Product Recall

Subject: RECALL 05V-137, 05-078 (Canada #) Tie Rod Assembly

Product Recall Repair Procedure Recall 05V-137 05-078 - Tie Rod

Step 3

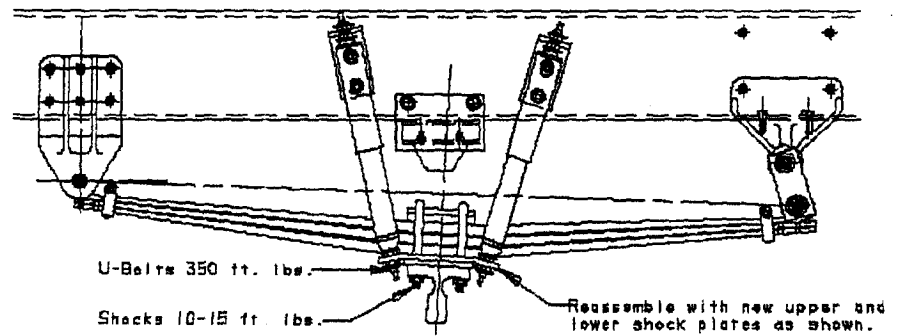
- 6) Lower unit back on to the axle
- 7) Install new u-bolts 61300207 and existing washers, nuts 61370115 provided in kit. **Step 3.**

- 8) Torque front u-bolts to 350 ft/lbs T/-50 in gradual increments of 100 ft/lbs to prevent areas of high stress in the u-bolts and spring seating.
- 9) Reconnect front shock absorbers.
